**EXPRESS TERMS
FOR
PROPOSED BUILDING STANDARDS
OF THE
DEPARTMENT OF HOUSING AND COMMUNITY DEVELOPMENT
REGARDING PROPOSED CHANGES TO THE 2007 CALIFORNIA BUILDING CODE (CBC)
CALIFORNIA CODE OF REGULATIONS, TITLE 24, PART 2
(HCD 02/07)**

The Department of Housing and Community Development (HCD) proposes to make necessary changes to the 2007 edition of the California Building Code (CBC), based on the 2006 International Building Code (IBC), as presented on the following pages. HCD further proposes to:

FIGURE 11A-6A—WARNING STRIPING AND HANDRAIL EXTENSIONS

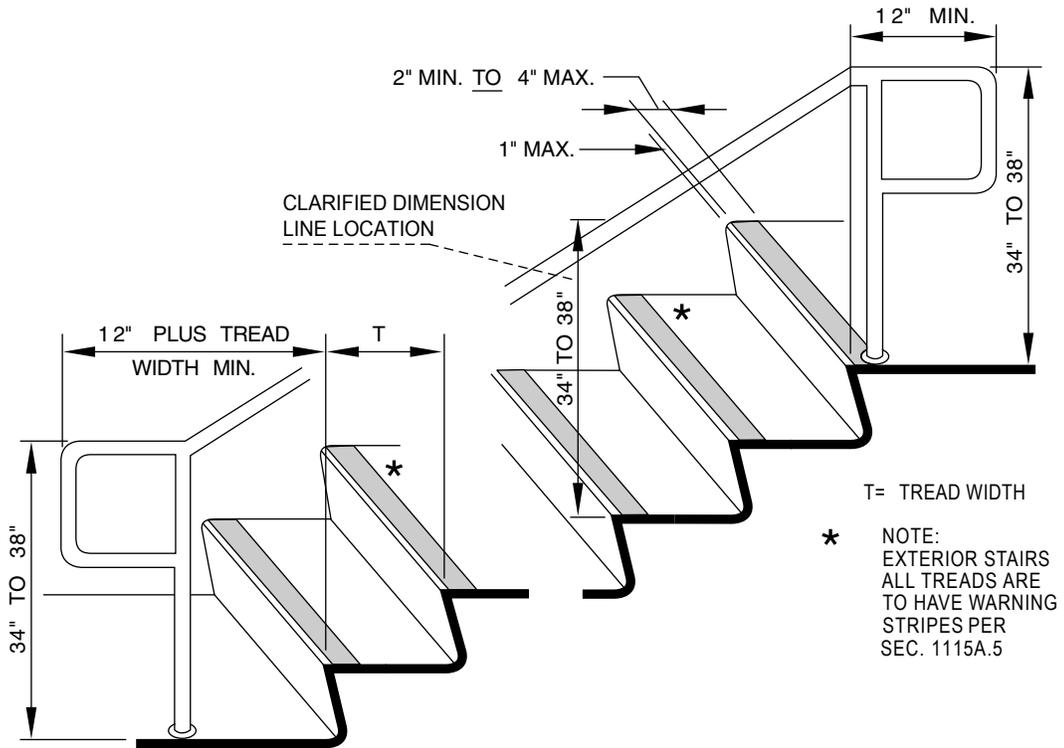
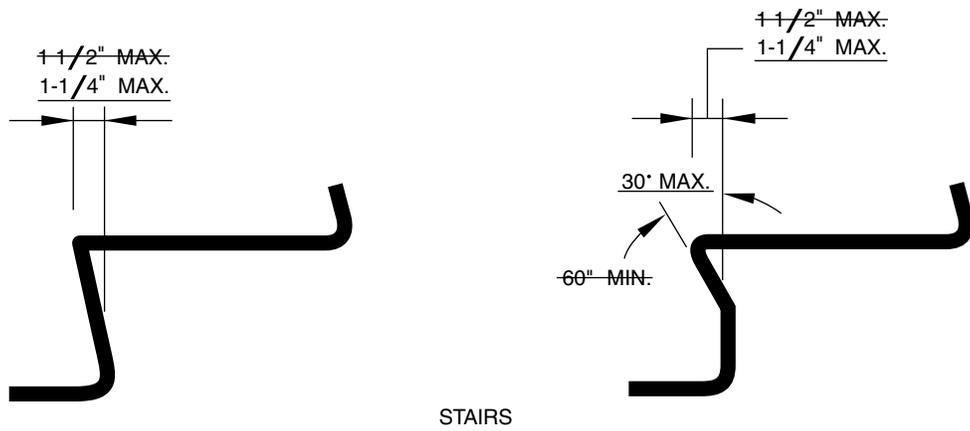
1115A.4 Nosing. Nosing shall not project more than ~~4 ¼~~ 1 ¼ inches (~~38.1~~ 31.8 mm) past the face of the riser below. Risers shall be sloped or the underside of the nosing shall have an angle not ~~less~~ more than ~~60~~ 30 degrees (0.52 rad) from the ~~horizontal~~ vertical. (See Figure 11A-6A).

1123A.4 Nosing. Nosing shall not project more than ~~1½~~ 1¼ inches (~~38.1~~ 31.8 mm) past the face of the riser below. Risers shall be sloped or the underside of the nosing shall have an angle not ~~less more~~ than 60 30 degrees (0.52 rad) from the ~~horizontal~~ vertical. (See Figure 11A-6A)

1123A.6.2.3 Handrail extension. Handrails shall extend a minimum of 12 inches (305 mm) beyond the top nosing and 12 inches (305 mm), plus the tread width, beyond the bottom nosing. Where the extension creates a hazard, the termination of the extension shall be rounded or returned smoothly to floor, wall or post. Where the stairs are continuous from landing to landing, the inner rail shall be continuous and need not extend out into the landing. (See Figures 11A-6A and 11A-6E).

33. Amend Figure 11A-6A “WARNING STRIPING AND HANDRAIL EXTENSIONS”:

FIGURE 11A-8J – PLATFORM AT SECONDARY EXTERIOR DOOR

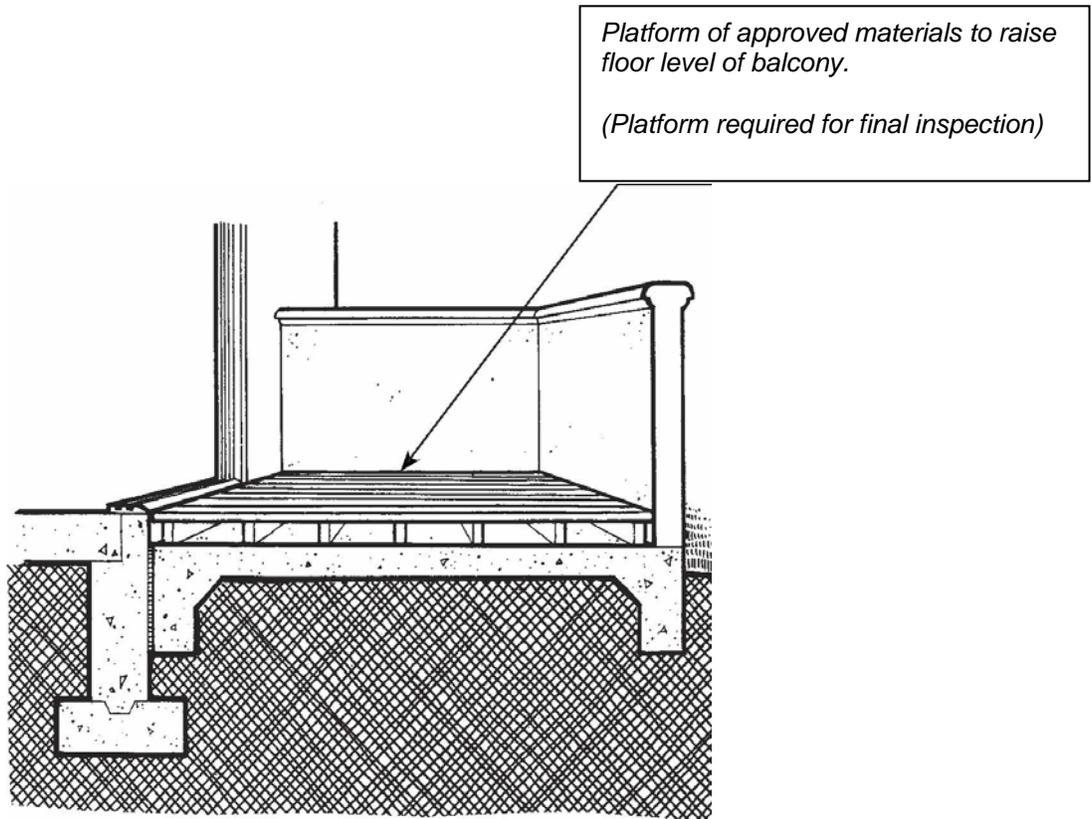
3. Secondary exterior doors onto decks, patios or balcony surfaces constructed of impervious materials (e.g., concrete, brick, flagstone) may have a maximum change in height from the interior landing of 4 inches (101.6 mm). Changes in height greater than ½ inch (12.7 mm) shall be accomplished by means of a ramp complying with Section 1114A or by means of a platform constructed to the level of the floor as illustrated in Figure 11A-8J.

Figures 11A-8J “Platform at Secondary Exterior Door”; 11A-8K “Ramp at Secondary Exterior Door”; 11A-9L “Shower with Water Closet”; and 11A-9M “Wing Wall or Cabinet at Water Closet” are added (see attached.)

FIGURE 11A-8K – RAMP AT SECONDARY EXTERIOR DOOR

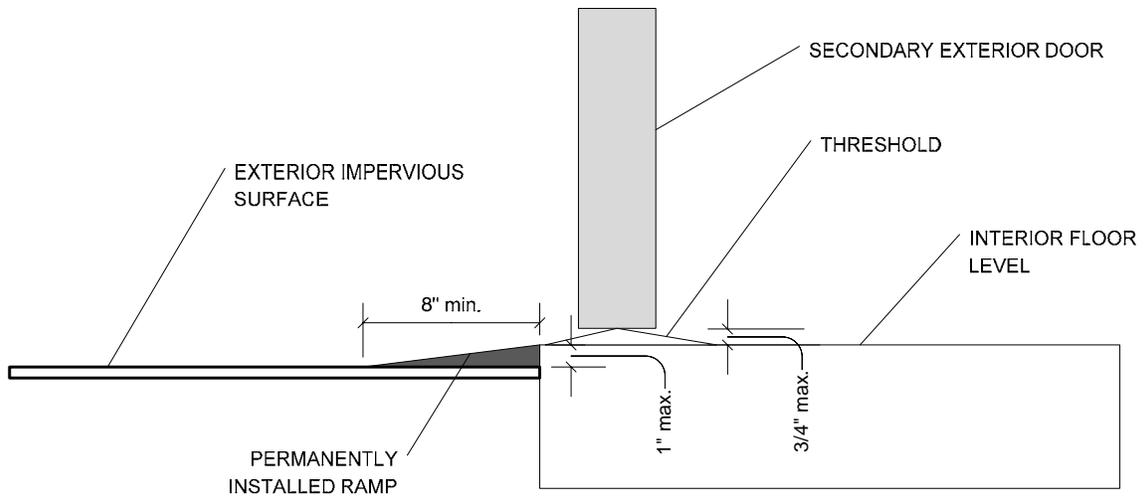
4. Secondary exterior doors onto decks, patios or balcony surfaces constructed of impervious materials (e.g., concrete, brick, flagstone) may have a maximum change in height from the interior landing of 1 inch (25.4 mm), provided a ramp with a maximum slope of 1:8 is permanently installed. (See Figure 11A-8K.)

FIGURE 11A-9L – SHOWER WITH WATER CLOSET

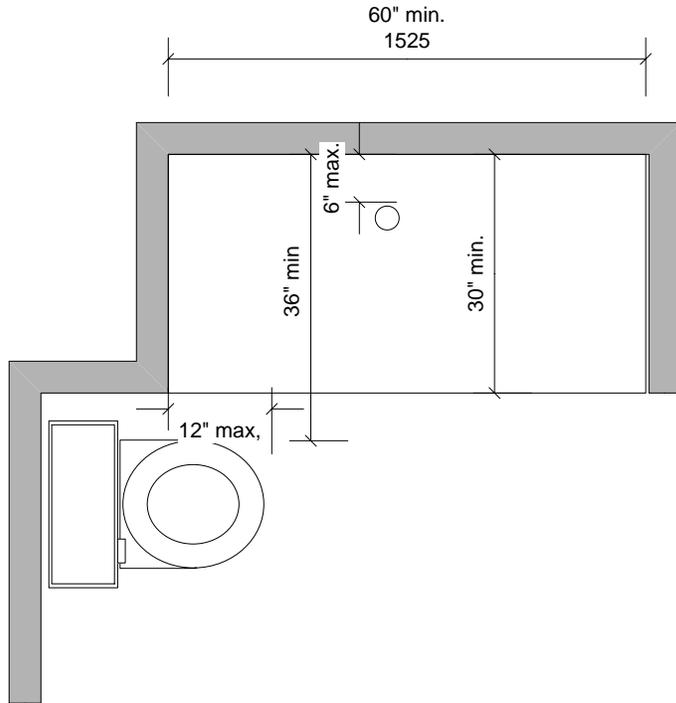
~~1.2 The shower stall shall measure at least 30 inches deep by 60 inches wide (762 mm by 1524 mm) with an entrance opening of at least 60 inches (1524 mm). A water closet may project a maximum of 12 inches (305 mm) into the opening provided that a minimum of 36 inches (914 mm) clear space is maintained between the water closet and the shower wall as illustrated in Figure 11A-9L or;~~

FIGURE 11A-9M – WING WALL OR CABINET AT WATER CLOSET

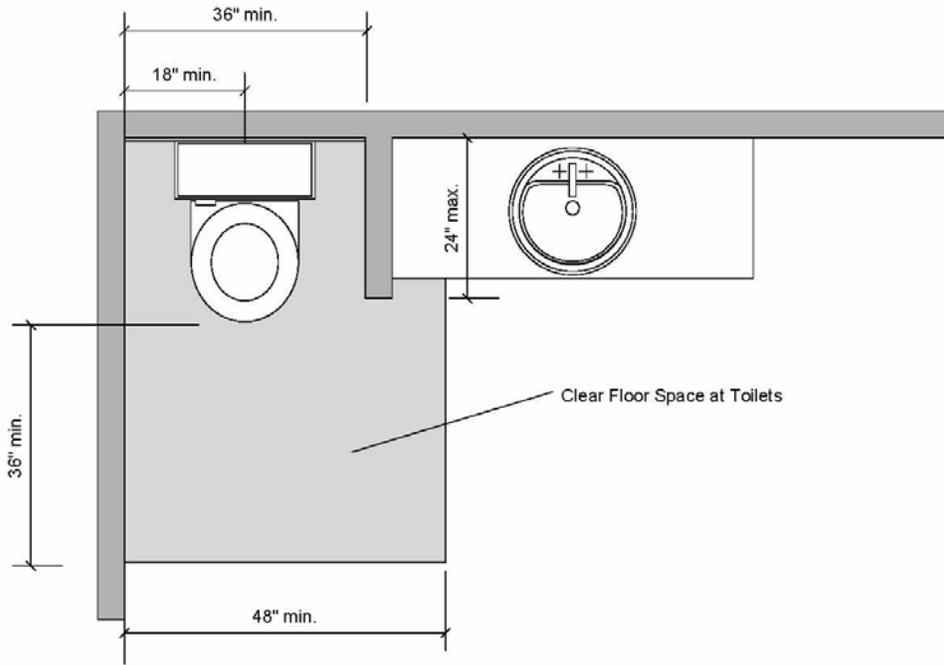
~~1. Floor Space. The water closet shall be located in a space a minimum of 36 inches (914 mm) in clear width with 48 inches (1219 mm) minimum clear space provided in front of the water closet. This space may include maneuverable space under a lavatory, if provided and arranged so as not to impede access. The minimum floor space provided at a water closet shall be 48 inches (1219 mm) in clear width. The clear floor space shall extend past the front edge of the water closet at least 36 inches (914 mm). See Figure 11A-9M.~~
